Nomination Form Anadromous Waters Catalog

111-40-10100 CORRECTION

Water body name: Lemon Creek

Nom#24-512

Figure 1.–111-40-10100 route correction map.

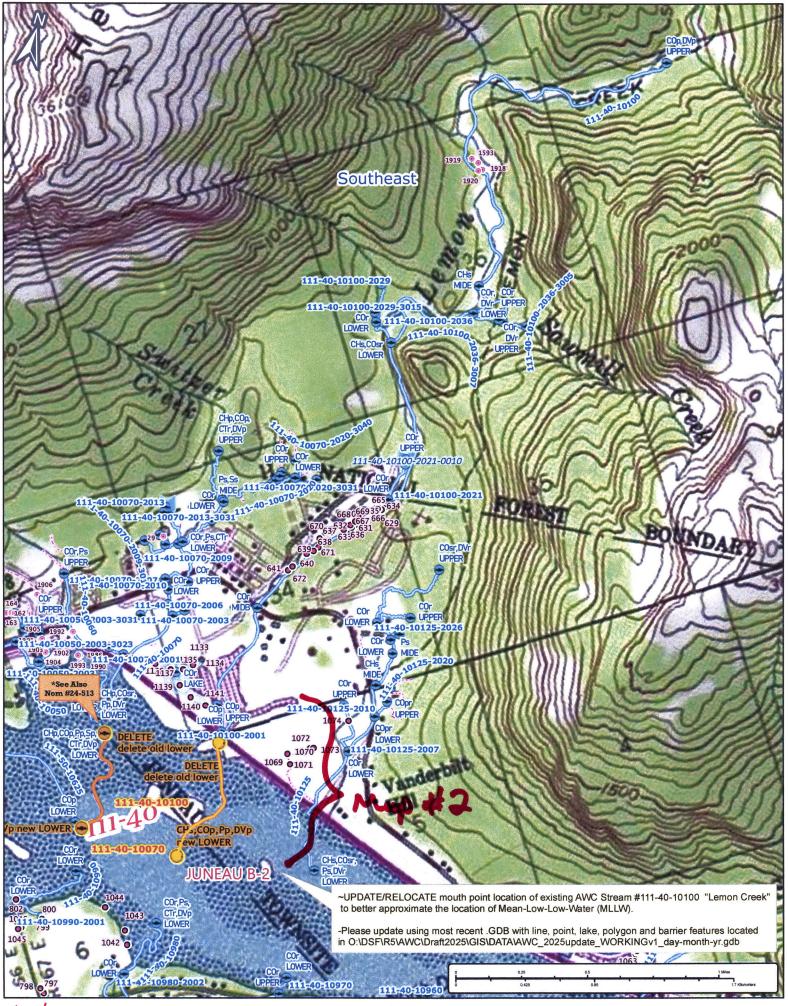
Findings: We surveyed this cataloged stream and found that the stream path is incorrectly mapped. The lower reach of the stream should be extended for clarification, particularly in light of potential alternatives identified for eventual construction of a second bridge crossing between Juneau and Douglas.

Recommendations: Correct Stream No. 111-40-10100 in the anadromous waters catalog to reflect the field verified stream path. Please extend stream into the intertidal (Figure 1).
